Site Survey of Selected Items
for
Compliance with the Americans with Disabilities Act
(ADAAG)
and
Title 24 of the CBC

The site survey of William Howard Taft High School was conducted on February 26, 2007 during a spot check for compliance with the Americans with Disabilities Act Guidelines (ADAAG) and Title 24 of the CBC

Facility Name: William Howard Taft High School

Boys Restroom Building M

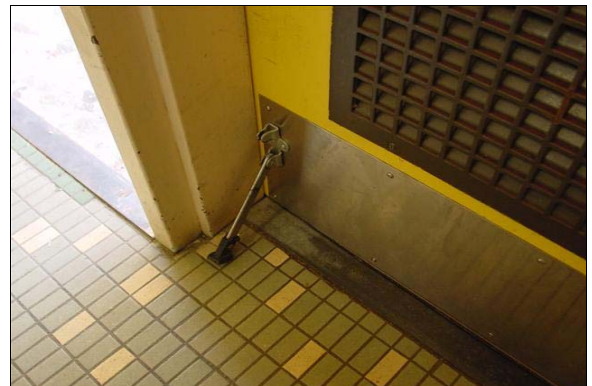
Finding: There is signage indicating accessibility on the entry door to the restroom. The signage is centered 60 inches above the floor on the latch side of the entrance door and includes Braille and raised lettering, gender use symbol and the ISA symbol.

Full Rec The restroom is designated accessible and should be made an accessible restroom for the facility. Monitor signage for continued compliance with CBC 1115B.5, ADAAG 4.1.2(7) and ADAAG 4.1.6(3)(e) and ADAAG 4.30.

Boys Restroom Building M

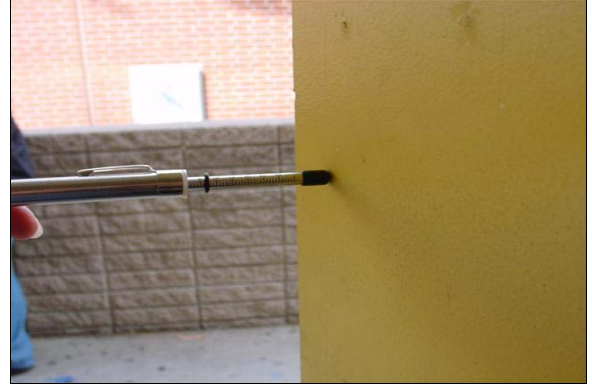
Finding: The bottom 10 inches of the door does not provide a smooth, uninterrupted surface, or panel to allow the door to be opened by a wheelchair footrest without creating a trap or hazardous condition, due to a doorstop.

Full Rec Remove the doorstop from the door to provide a smooth, uninterrupted surface for the bottom 10 inches of the door.
